ADDENDUM NO. 1

GMIA, PARKING STRUCTURE RELIGHTING

PROJECT NO. A096-10012

GENERAL MITCHELL INTERNATIONAL AIRPORT
Milwaukee County, Wisconsin

PROJECT NO. PS-E0.30
 A096-10012

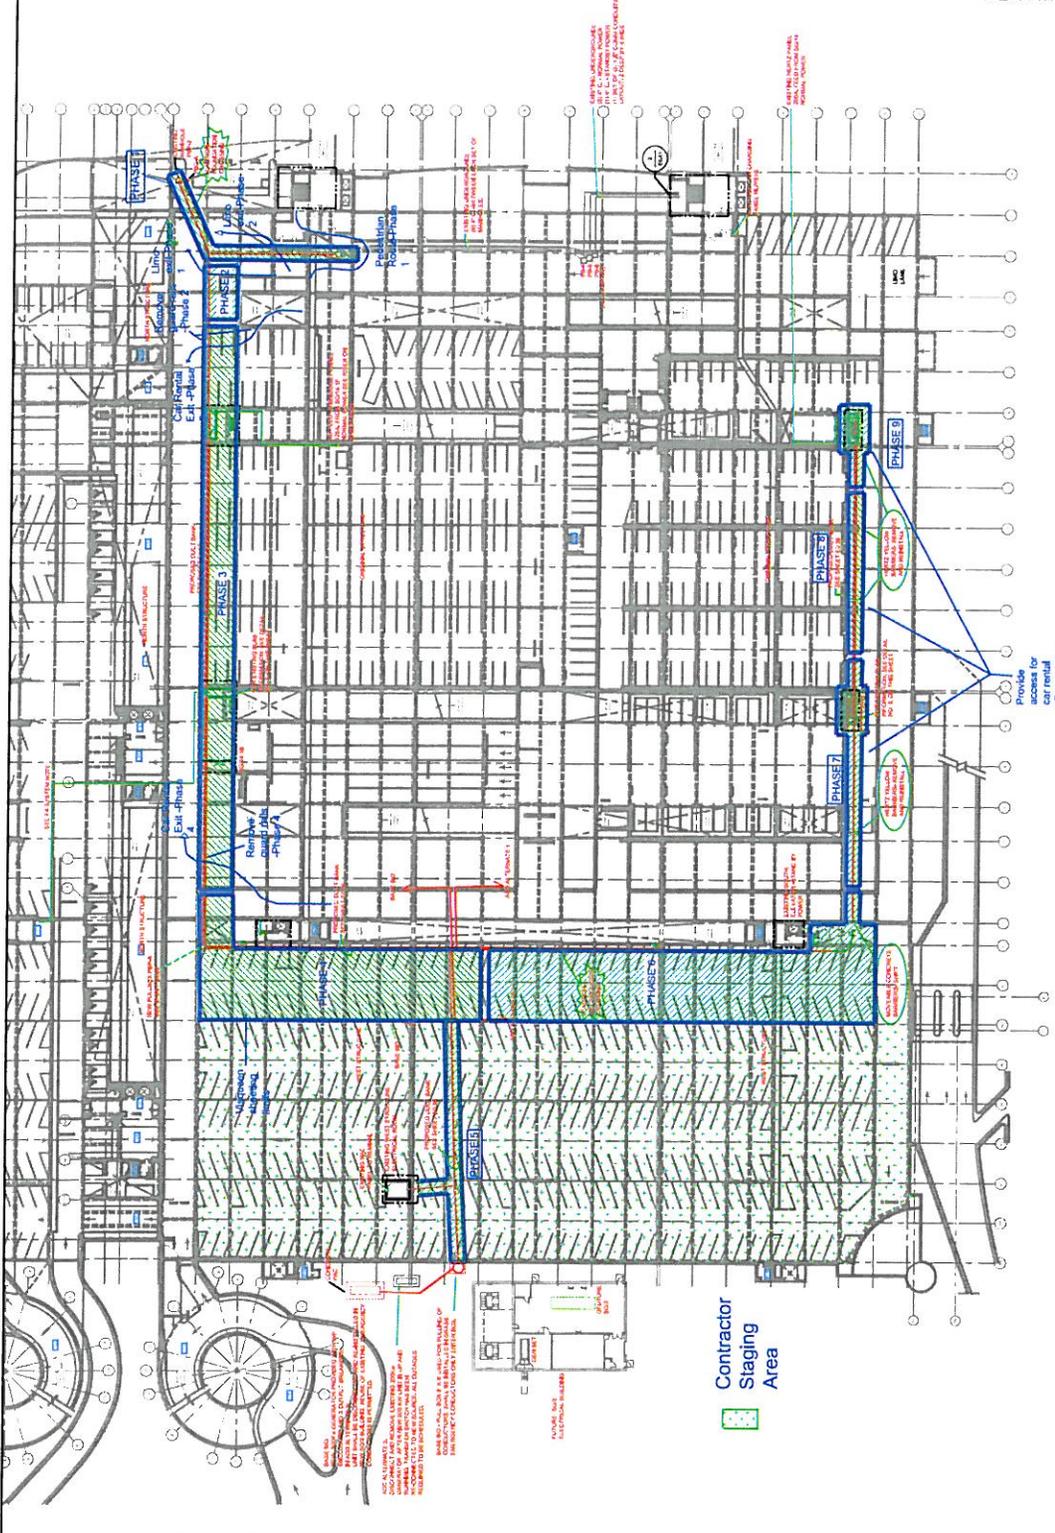
PS-E0.30

- Along C-7 to C-14, cut and remove Hertz yellow rails during installation of under floor duct package. Once complete, replace and paint cut edge to match.
- foundation details 2 & 3 – clarification – where quantities of 6 or more conduits pass through concrete contractor to locate the opening(s) 2 feet below the top of slab, coring or cutting a window in the wall of the foundation is acceptable.
- Clarification – At West structure conduit exit location 8’ x 8’ enclosure shall be Hubbell no. EOC969644A, or approved equal, installed per manufactures recommendations.

REMOTE CLOSET SG/14-2F

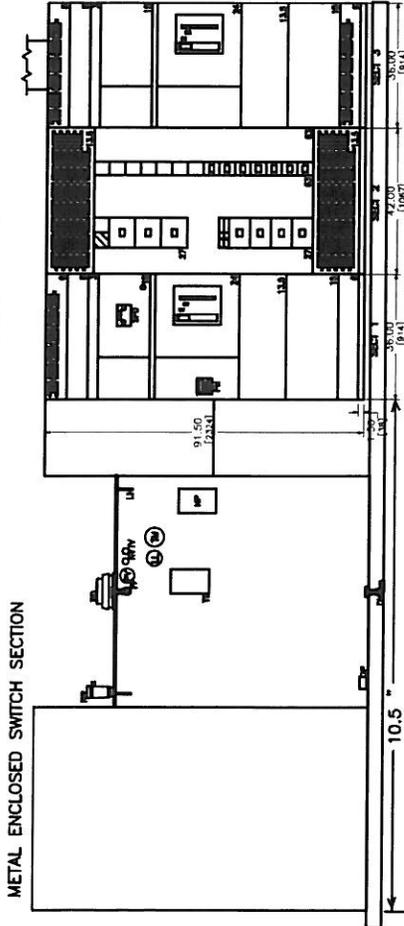
PS-E.032

- In lieu of wall shown between electrical room and communication room, provide a fence and entry door similar to the other electrical closets such as “A” or “E”.
- detail 4: DELETE notation – “re-lamp and re-ballast”, GMIA staff shall correct themselves.
- ADD note no. 21 to sheet notes “Remove and reinstall strobe unit into remaining elevator lobby, locate 80” AFF.”

NEW- DOUBLE ENDED - SWITCHGEAR DETAIL - SG/14

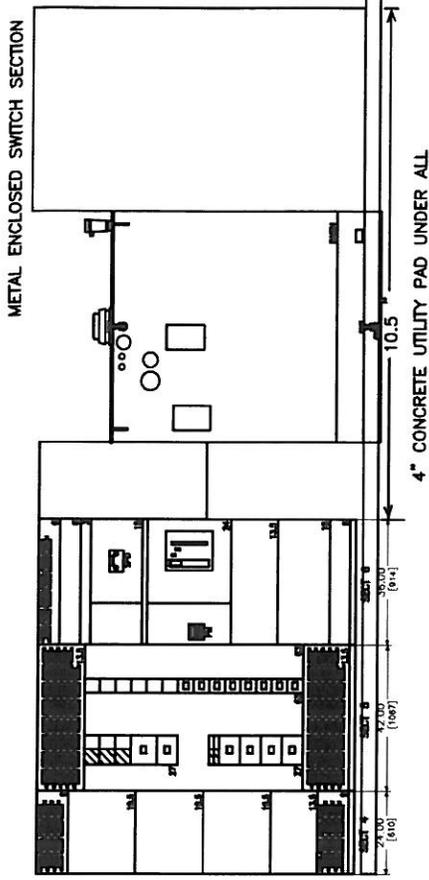
PS-E0.45

- See attached elevation of gear (sheet E-2) which identifies quantity and location of feeder breakers.

SG/14-1B FLOOR PLAN

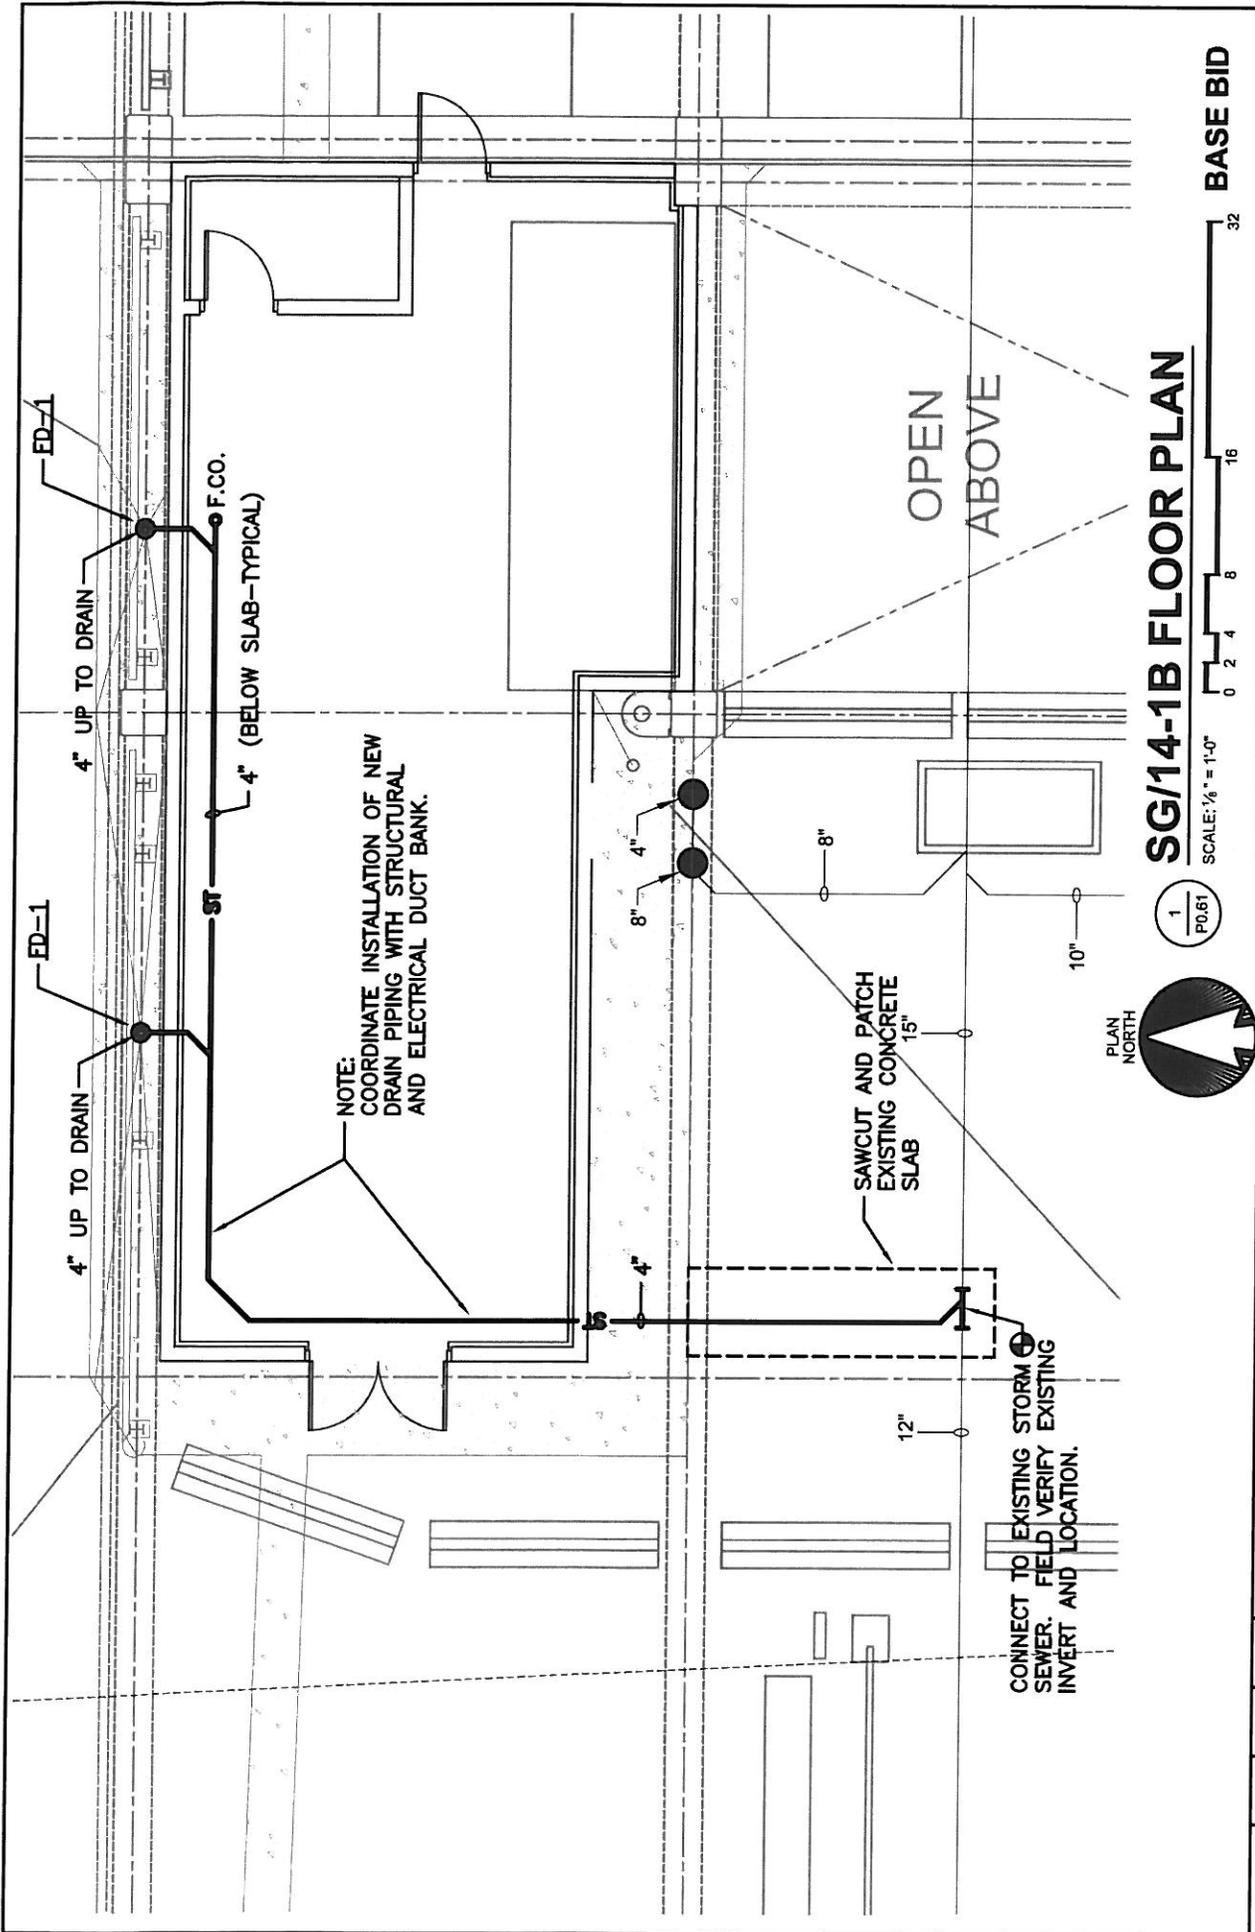
4. Includes the construction of one electrical room (SG/14-1B) & two electrical closets (SG/14-1F & SG14-1C). See architectural & electrical drawings.
5. Provide new pull box in northwest corner of duct package run.
